Black: reviewer's comments (RC1.1 to RC1.15)

RC1: 'Comment on egusphere-2025-3837', Anonymous Referee #1, 18 Sep 2025

Figure R1.1. New revised Figure 8 including Figure S3 as bottom panel.

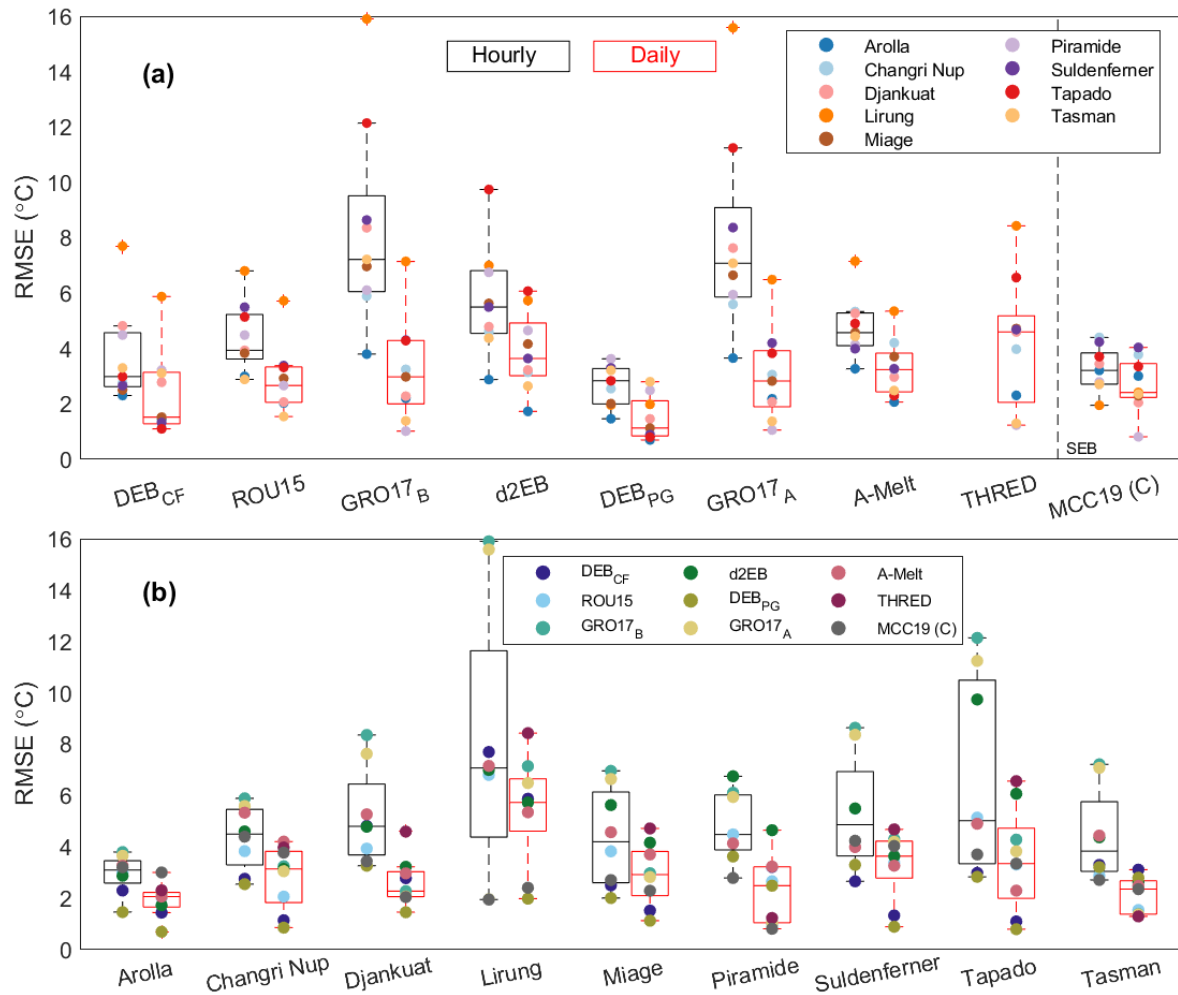
RC1.9 458-474: With this much discussion of Figure S3, it would be better to include it in the paper.

Thank you for the suggestion. We agree that Figure S3 is extensively discussed and could be included in the paper. We will include it together with Figure 8 arranged as two panels, as suggested below:
